The applicant is proposing a 38 story, mixed use project on the block bounded by University Street, 1st Avenue, Seneca Street, and 2nd Avenue. The petitioner plans to vacate a portion of an alley that connects University and Seneca streets and develop the project on approximately three-fourths of the combined block. The remaining portion of the block, currently occupied by the historic Diller Hotel, will remain. The partial alley vacation is approximately 2,560 square feet, with 1,280 square feet to remain. However, the applicant is currently working with the Diller family on agreement that would allow the applicant and the Diller family to pursue a full alley vacation.

This was the Seattle Design Commission's (SDC) first review of the proposed public benefit. Following the presentation, public comment and SDC review and deliberation, the SDC voted 9-0 in favor of the public benefit package, with several conditions and recommendations.

**October 16, 2015****9:00 – 11:00 am****Type**

Public Benefit

a: Proposed open space

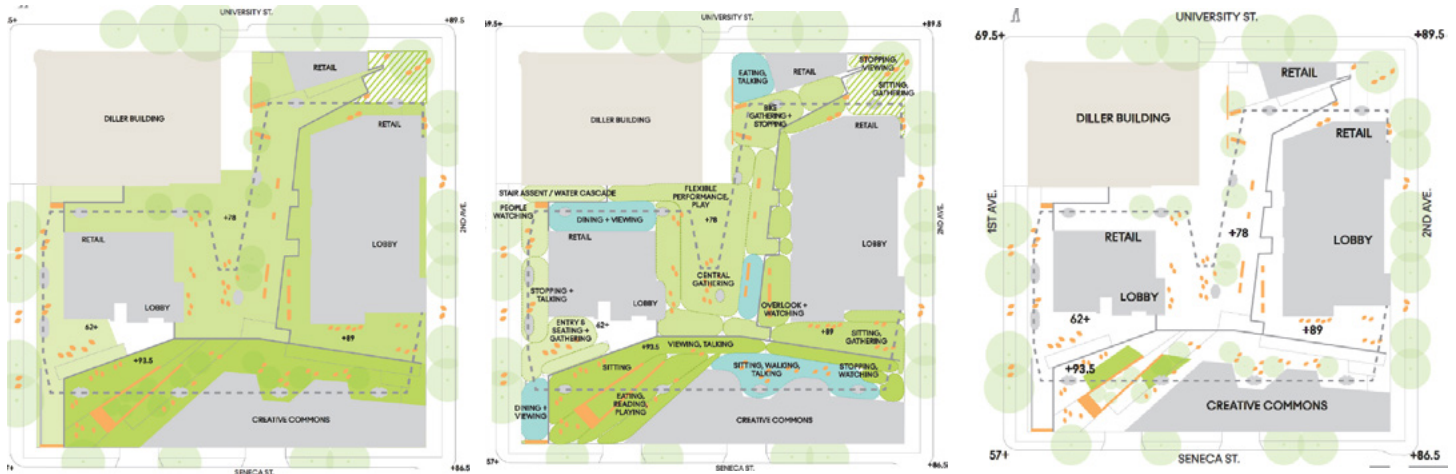
1. Prior to the issuance of a Master Use Permit, SDC will review the additional programming related to the family-friendly components of the public open space. Specific details related to the family friendly components should include lighting, public safety, and hours of operation, as well as long-term management plans for the proposed space.

g: Circulation

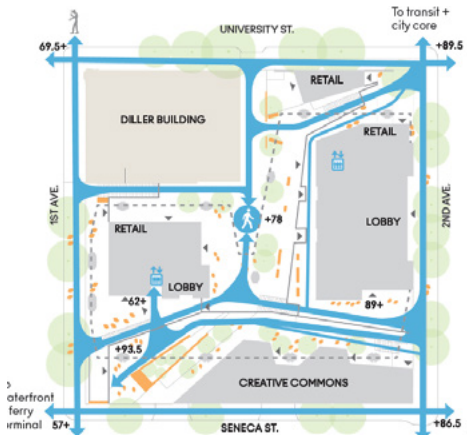
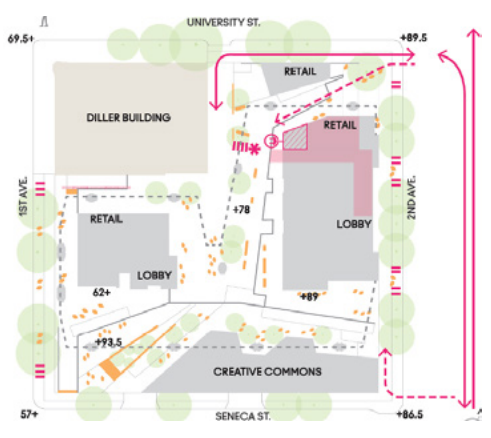
**Lloyd Douglas**, of the Cascade Neighborhood Council, is concerned with navigation and wayfinding throughout the project site. More specifically, Mr. Douglas is concerned with the lack of clear signage and graphics near public entrances. Mr. Douglas stated the project team should be required to have a signs that shows how pedestrians are going navigate through an area that includes such a significant grade change.

Overall, the Commission understands the building lift is critical in creating publicly accessible open space. The SDC appreciates changes made to the design in order to make site edges and entrances more welcoming to pedestrians, especially the entrance along 1st Ave and Seneca St. The Commission noted the lift concept allowed for a better integration of proposed site features with the existing Diller Hotel. Commissioners agree added programmable areas underneath the lift, especially family friendly areas and areas for arts and culture help create a better quality public space. The SDC expressed concern with the lack of wayfinding and lighting throughout the site and encouraged the

design team to further create a safe and accessible environment underneath the building lift by providing additional signage and pedestrian oriented lighting. The SDC wants to make sure that the accessible pathways through the space are very obvious, inviting, visible, and clear. The SDC is also concerned with the lack of programming for two designated areas. The Commission recommends the design team come back for an administrative review once programming details have been decided for the family friendly and arts and culture areas. The SDC also recommends the project team provide a detailed list of guidelines regarding long-term management in the event they decide to sell the project upon completion of construction. The intent here is to create guidelines for management, while still allowing the applicant flexibility over the life of the building.

4. Prior to the issuance of a Master Use Permit, SDC will review the location of additional wayfinding identifying accessible routes throughout the site, including to onsite elevators that provide accessible routes.
